GENOA CHARTER TOWNSHIP ZONING BOARD OF APPEALS March 17, 2015, 6:30 P.M. AGENDA

MEMORANDUM

DATE: March 10, 2015 **RE:** ZBA 15-03

STAFF REPORT

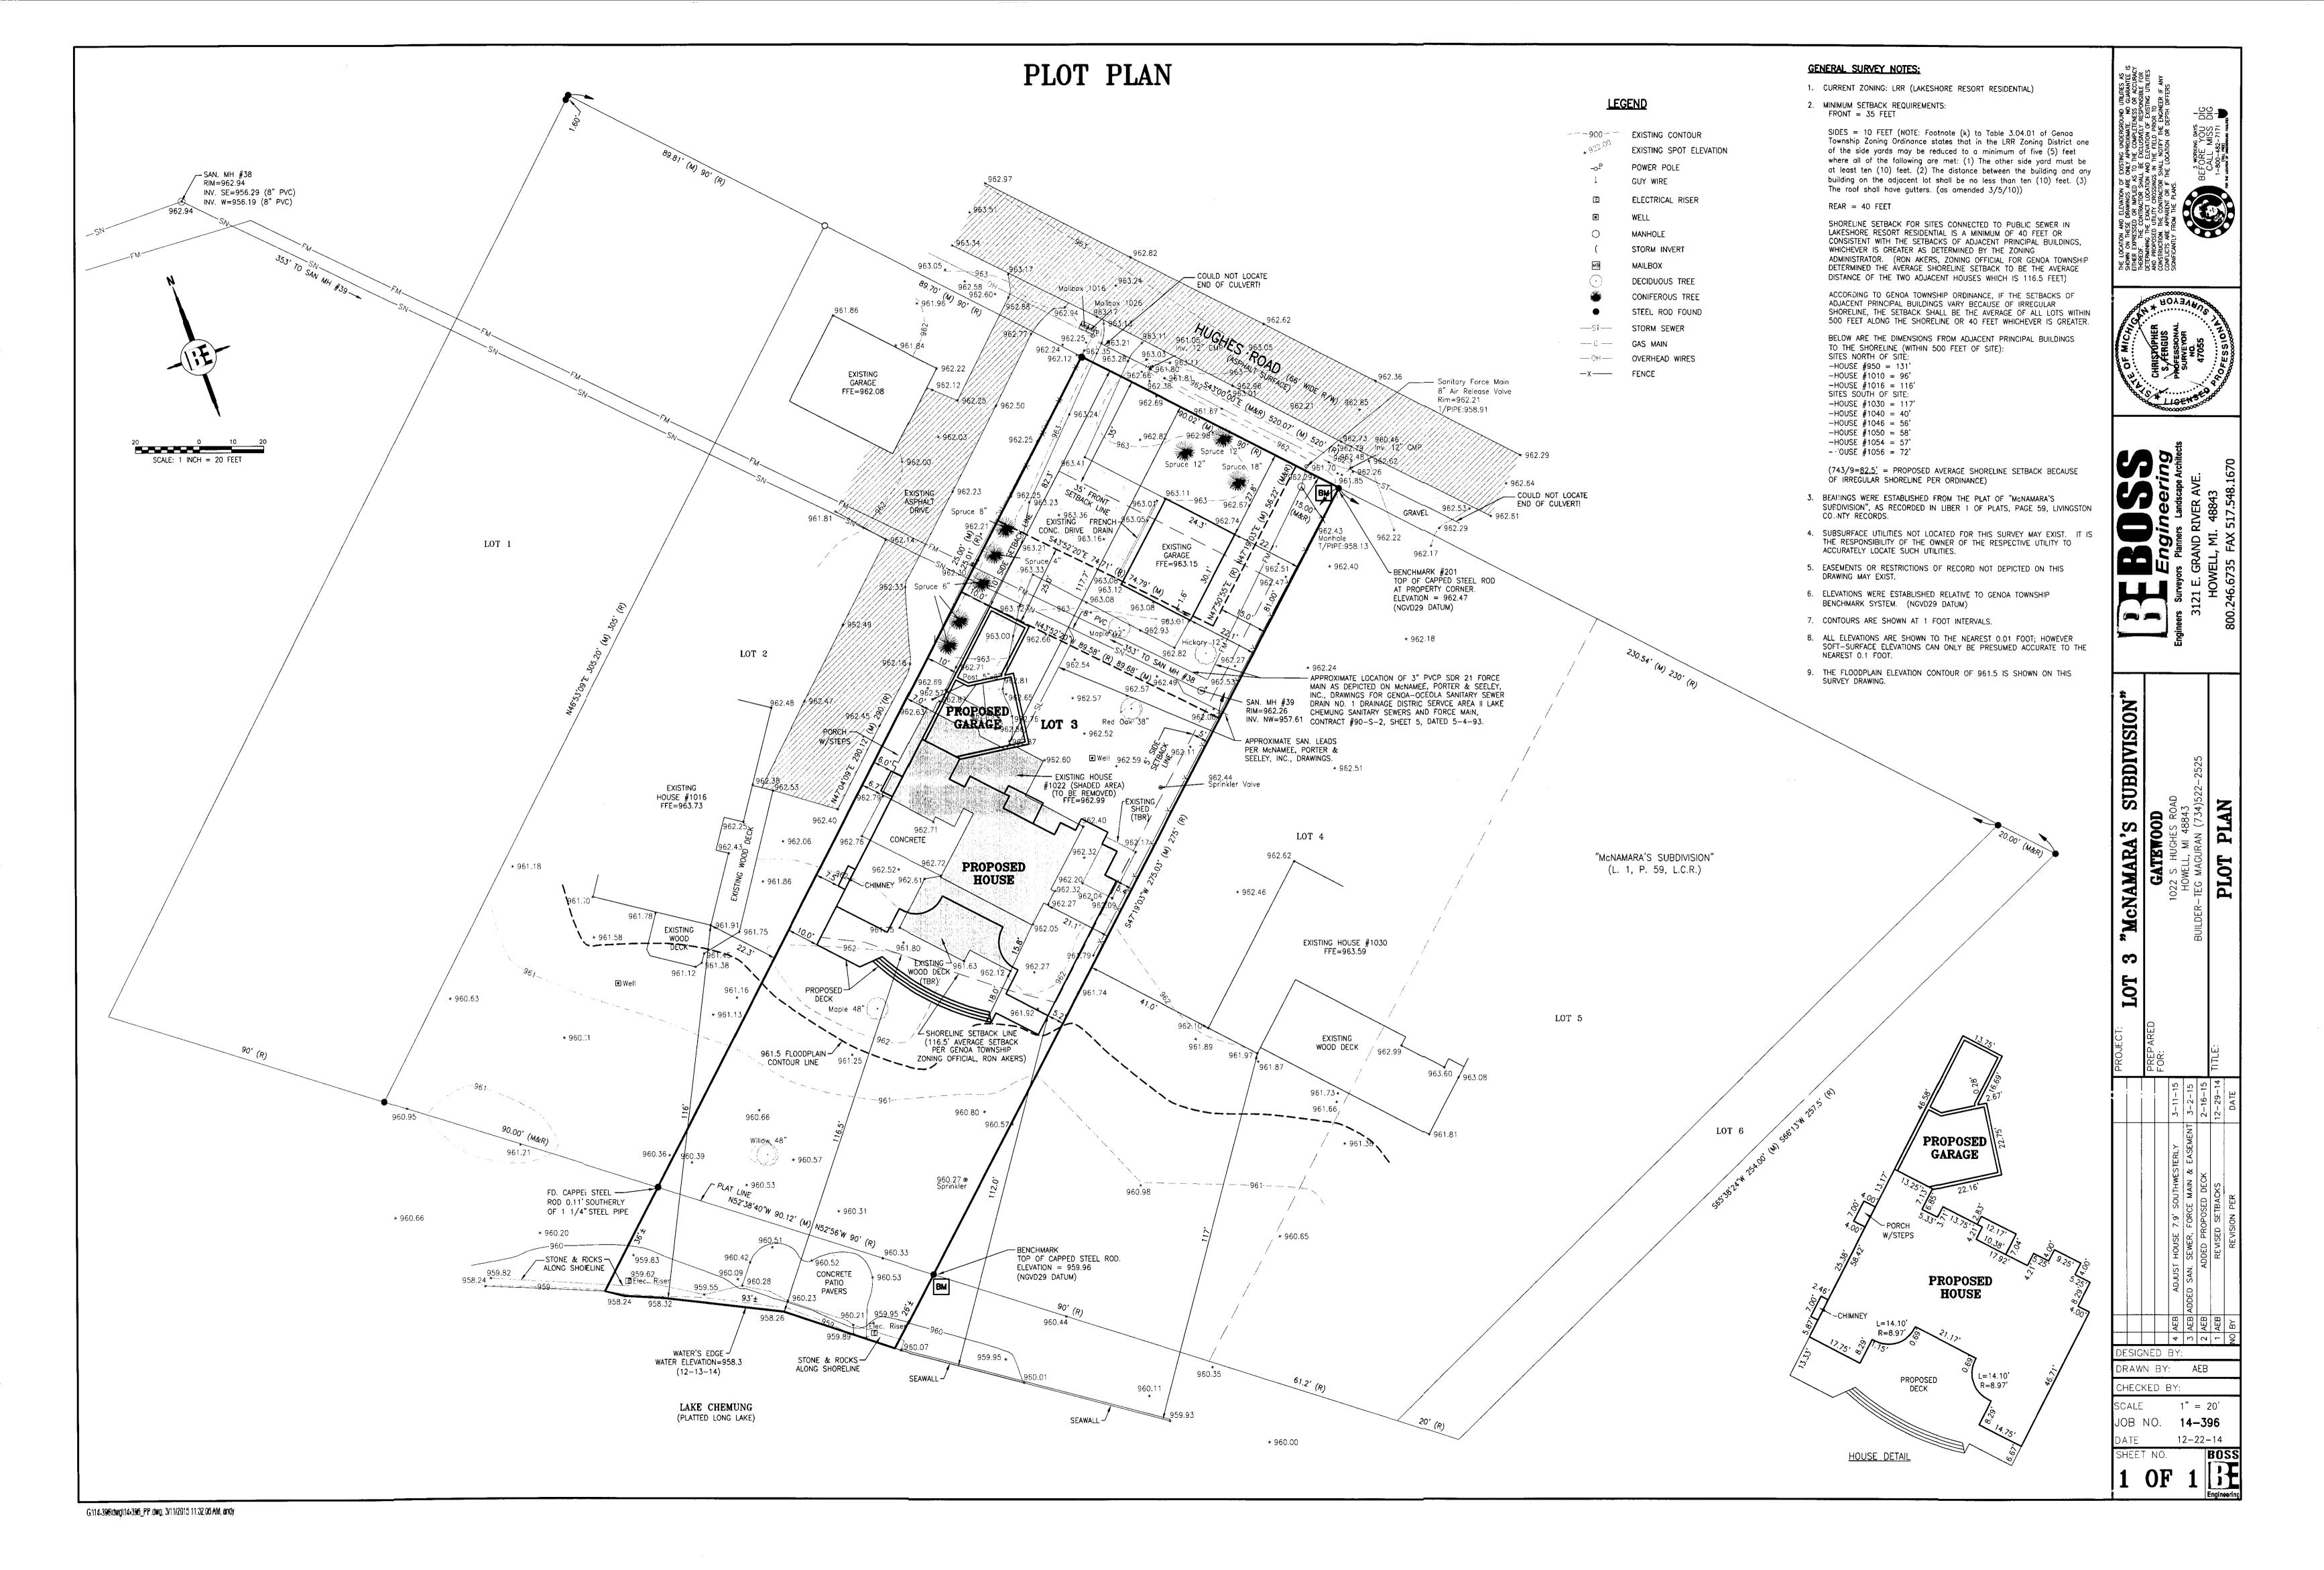
- A. <u>Height Variance</u> The applicant has stated that strict compliance with the height requirements in the Zoning Ordinance would unreasonably prevent them from constructing a two story home on the property. The applicant has raised the first floor height of the building to approximately 4'2" to ensure that the finished floor height is far enough above the water table (which according to the applicant is only at 12" in spots) to ensure that the moisture does not rot the floor joists. The presence of the high water table does present a difficulty for the applicant to construct their proposed home because they are unable to construct the home on a lower foundation such as a slab which would conform with the height requirements in the Zoning Ordinance.

- B. <u>Side Yard Setback Variance</u> Strict compliance with the side yard setback would create difficulties in fully utilizing the available building envelope on the property. As depicted on the site plan, there is a sewer main easement which bisects the property between the detached garage and existing house. Due to the applicants inability to building a structure within that easement the depth aspect of the building envelope is limited which causes the applicant to fully utilize the lot width. The only portion

- of the structure that does not comply with the side yard setback requirements for the LRR district is the chimney which extends 2.5' out further than the wall of the building. There are no allowable exceptions in the Zoning Ordinance to allow for this without a variance. The applicants have made an effort to ensure the actual house wall is within the required setbacks.

- C. Permitted Projection into Side Yard Strict compliance with the permitted projection into the required side yard for an unroofed porch would unreasonably prevent the use of the side door because it would prevent the property owners from having the ability to fully open a three foot door. Building code requires that porches which exceed 31" have railings installed on them and if these railings are installed within the allowable deck footprint it would not leave sufficient space for a three foot door to fully swing open. This is a concern because a three foot door is an ADA standard.

- A. <u>Height Variance</u> The extraordinary circumstances are due to the high water table (12" below surface in some locations) on the property which creates a need to construct the home on a crawl space and maintain a higher than normal finished floor height.

- B. <u>Side Yard Setback Variance</u> The exceptional or extraordinary circumstances that are applicable to this property is the presence of a sewer easement which bisects the property between the house and detached garage. This limits the building envelope on the property and creates the need for the side yard setback variance.

- C. <u>Permitted Projection into Side Yard</u> As discussed in the previous request, the presence of the sewer main easement is an extraordinary circumstance applicable to the property. The need for this variance is created by the zoning requirement which would prevent the applicant from fully opening a three foot door and the required height of the unroofed porch.
